A12 Chelmsford to A120 widening scheme

TR010060

9.61 Applicant's Comments on Information received at Deadline 5

Version	Date	Status of Version
Rev 1	12 June 2023	For Deadline 6

Plate 2.2 A12 Proposed Scheme Earthworks Deficit Plan

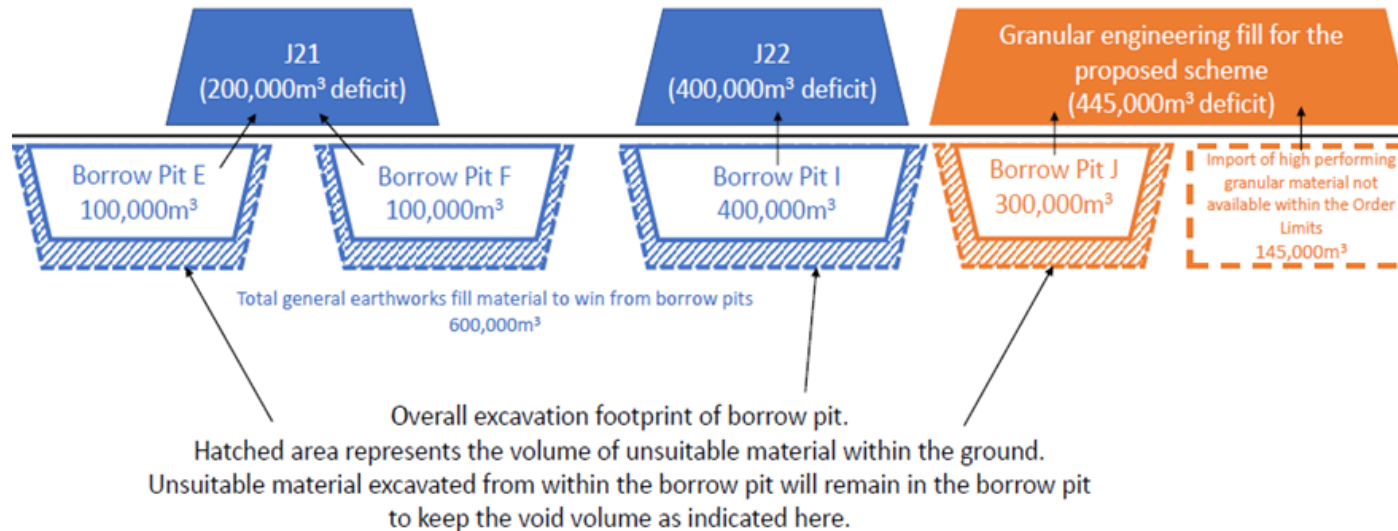
The volumes justifying the need for the land for borrow pits has been graphically represented in the Borrow Pits Summary Report [REP5-015] in Plates 2.1 and 2.2 to further clarify the figures that have been stated in the earlier submissions. The stated need of 600,000m³ of general earthworks fill material is correct, as shown in Plate 2.1. However, when totalling the volume of material

Ignoring the contingency need to backfill Coleman's Farm Quarry, as mentioned by the Interested Parties representative in question 2.2, the need from borrow pits therefore totals 900,000m³ (600,000m³ general earthworks material and 300,000m³ of granular engineering material) as demonstrated in Plate 2.2.
